**CITY OF ROCKVILLE PLANNING DIVISION
STAFF REPORT**

SUBJECT: Preliminary Development Plan
Application PDP2003-00006 –
255 N. Washington Street

Applicant: Rockville Town Center LLC/KSI
Development

Oblique View of Subject Site from South

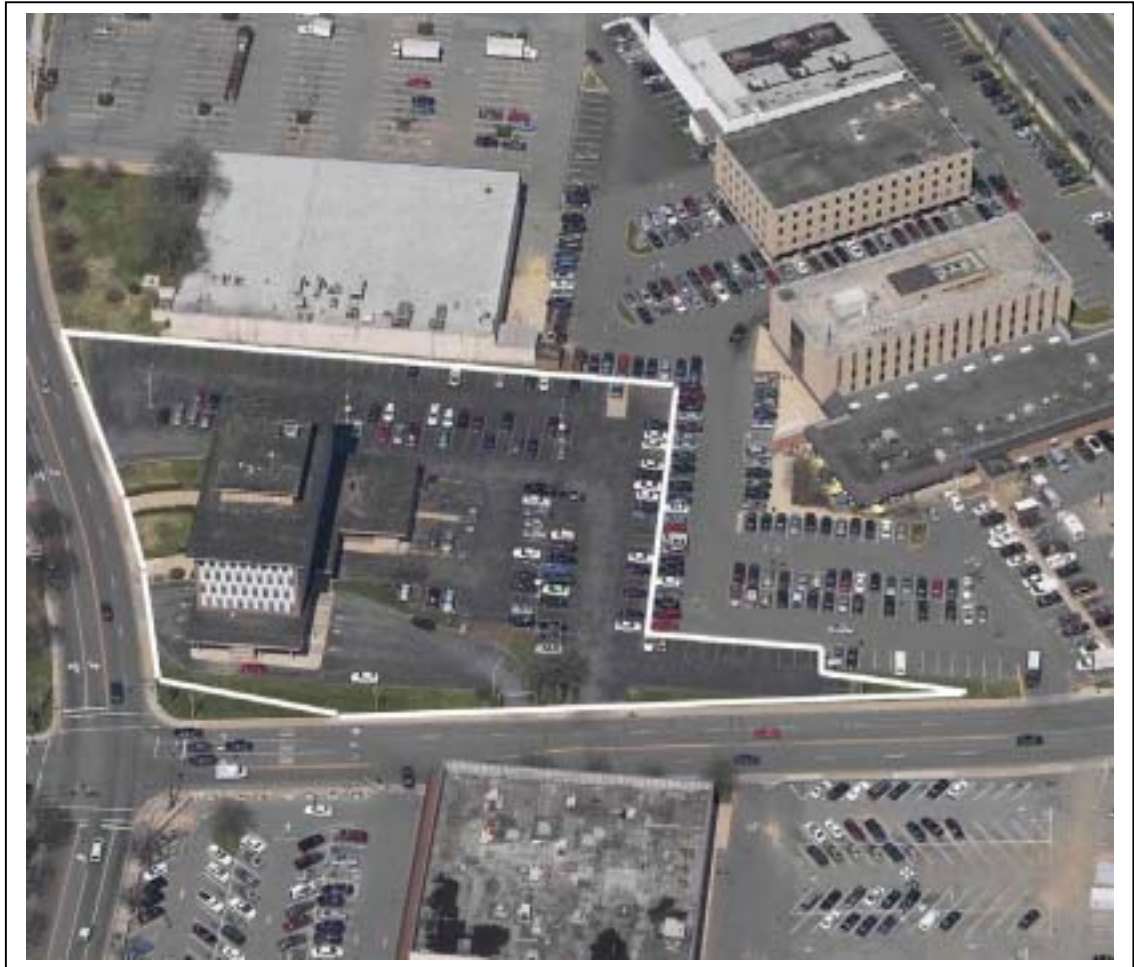
The applicant has further revised the application as of July 6, 2004. The latest revision calls for 6,549 square feet of gross floor area for a bank and retail on the ground level and 325 multi-family residential units (133 condominiums and 192 rental units). The project will consist of three residential sections in a “U” shape. The sections will be connected by a second-level plaza with private gardens, a pool, health club, and other amenity space. The section fronting on North Washington Street will contain the condominium units, including two-story townhouse style units at the street level. This portion of the project will be 75 feet tall (same as the initial proposal). The middle section, which will front on Beall Avenue, will be 85 feet tall (reduced from 100 feet in the initial application), and the third section will front on the future extension of

Maryland Avenue and will be 91 feet tall (reduced from 100 feet in the initial application) and contain the rental units. An area at the ground floor level beneath the first and second sections will house retail space and a bank with related drive-thru area and parking.
